Agenda Report

TO: Honorable Mayor and City Council
FROM: Planning & Community Development Department
SUBJECT: **PREDEVELOPMENT PLAN REVIEW OF PROJECT LOCATED AT 277 NORTH EL MOLINO AVENUE**

The proposed site plan is shown below.

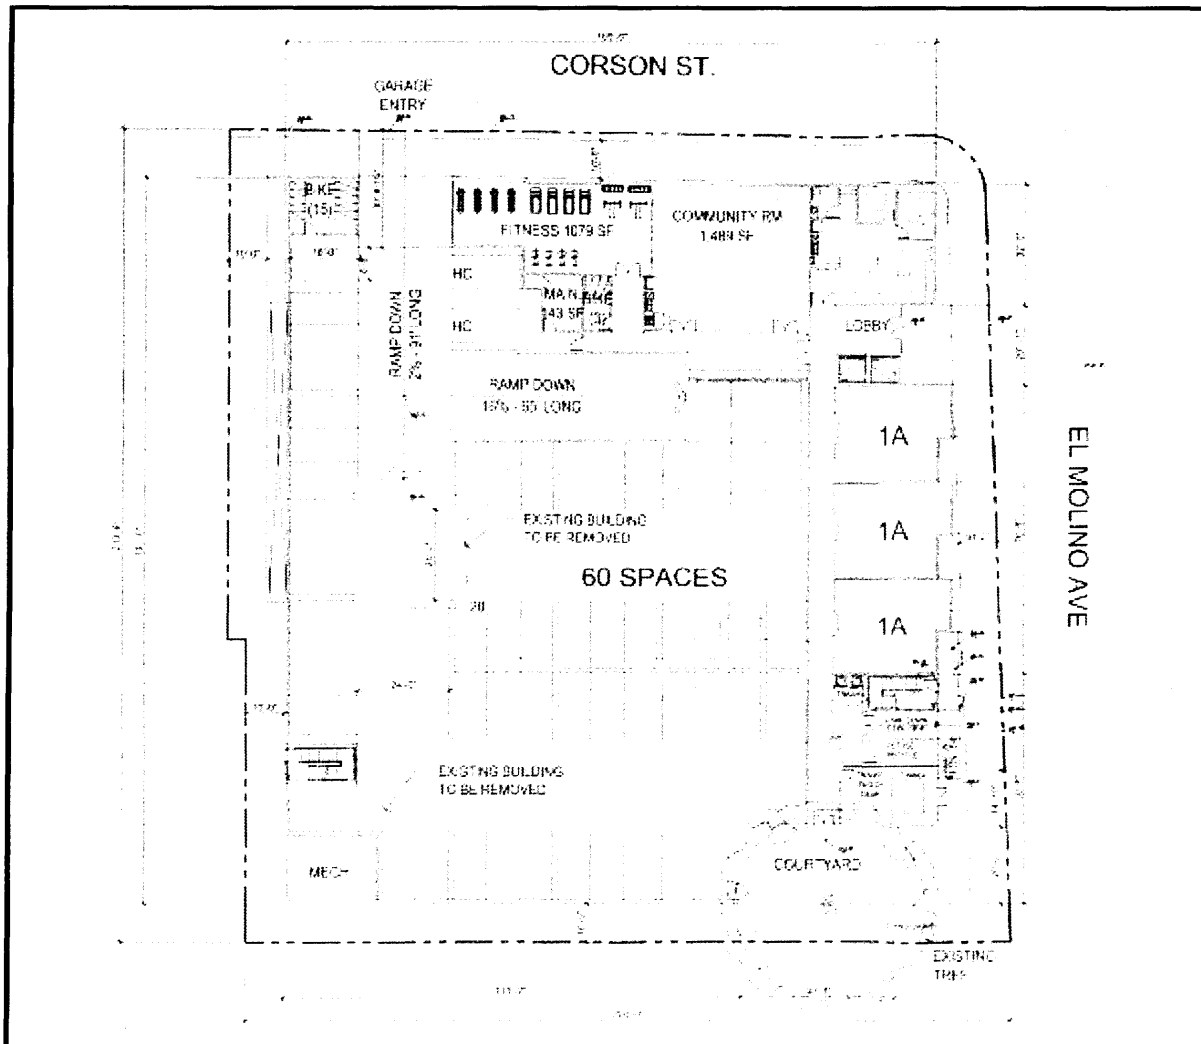
Based on the information presented, these findings may not be able to be met. From the submitted information, staff is not able to confirm that no more than 30 percent of the building footprint exceeds the height limit of 60 feet. As the project proceeds, the applicant will be required to provide more detailed information to ensure height averaging is complied with in order to request this approval of the Design Commission. Additionally, the Design Commission may impose additional conditions related to site planning, architectural design, as well as requiring public amenities, including public outdoor space and pedestrian paths.

From the preliminary plans submitted to the City, it appears that a portion of the proposed structure is encroaching into the required 10'-0" south side yard setback. As the project proceeds, the applicant will be required to revise the project to comply with the minimum setback requirement along all property lines, and provide more detailed information regarding the setback of the proposed balconies.

Although the maximum permitted setback along El Molino Avenue is 10 feet, as noted in the Public Works Department comments below, a 10 to 12 foot setback is recommended to protect the existing street trees. Per Section 17.30.050.A.1, exceptions to the setback may be encouraged for the purpose of protecting the character of a significant landscape, such as street trees.

From the submitted plans, a courtyard is proposed on the southeast corner of the property, at the street level visible from El Molino Avenue. Although the courtyard complies with the minimum dimensions, opening requirement and visibility from street, staff is encouraging the applicant to connect the landscaped courtyard with a proposed upper level pool area.

Corner Rounding – Land Dedication: In order to accommodate Americans with Disabilities Act (ADA) compliant curb ramps, the applicant shall dedicate to the City the land necessary to provide a 30-foot radius property line corner rounding at the southwest corner of Corson Street and El Molino Avenue.

1. Corson Street frontage - The building setback shall be 8 to 10 feet.
2. El Molino Avenue frontage - The building setback shall be 10 to 12 feet.

Driveway Configuration: The driveway and apron shall have a minimum width of 18-feet to accommodate 2-way traffic. And to improve the safety of pedestrians crossing the driveway, the design plans shall indicate a slope of 2 percent or less from the property line to 20-feet into the property to improve vehicular sight distance, or include the installation of an exit arm.

Access: It is recommended that a second access location off Corson Street be constructed to provide more vehicular circulation alternatives into and out of the parking garage.
